Architectural Review and
Historic Preservation Board
Agenda Report

File: AR 21-06

RE: Architectural Review 21-06 (North Fork Storage); Thorntree Drive, APN 016-200-122-000

Sheet Title
PLANTING PLAN

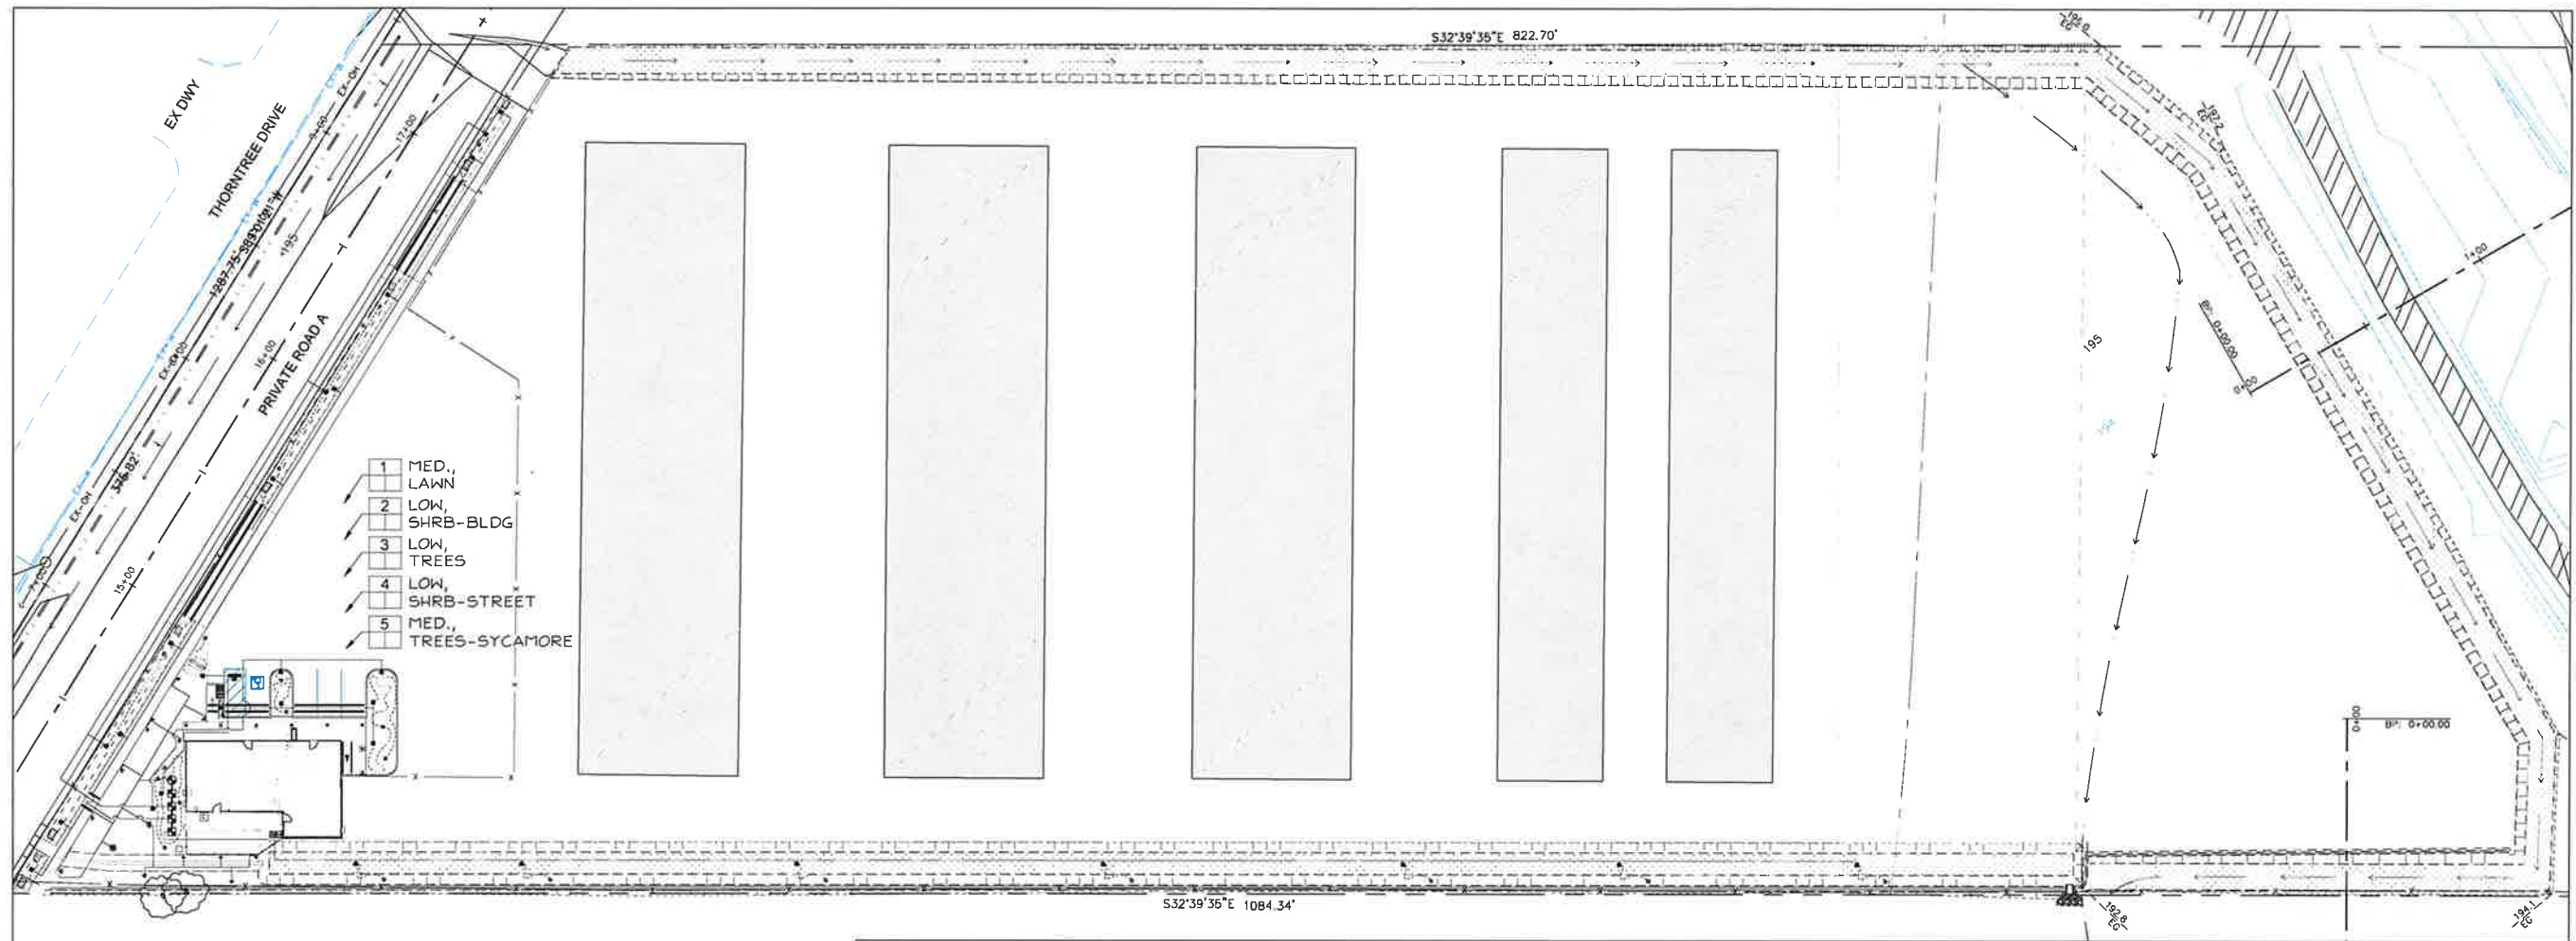
6. The landscape plan shall be modified to replace the proposed crape myrtle trees with species approved by the City's Urban Forester.
7. The applicant shall defend, indemnify, and hold harmless the City of Chico, its boards and commissions, officers and employees against and from any and all liabilities, demands, claims, actions or proceedings and costs and expenses incidental thereto (including costs of defense, settlement and reasonable attorney's fees), which any or all of them may suffer, incur, be responsible for or pay out as a result of or in connection with any challenge to or claim regarding the legality, validity, processing or adequacy associated with: (i) this requested entitlement; (ii) the proceedings undertaken in connection with the adoption or approval of this entitlement; (iii) any subsequent approvals or permits relating to this entitlement; (iv) the processing of occupancy permits and (v) any amendments to the approvals for this entitlement. The City of Chico shall promptly notify the applicant of any claim, action or proceeding which may be filed and shall cooperate fully in the defense, as provided for in Government code section 66474.9.
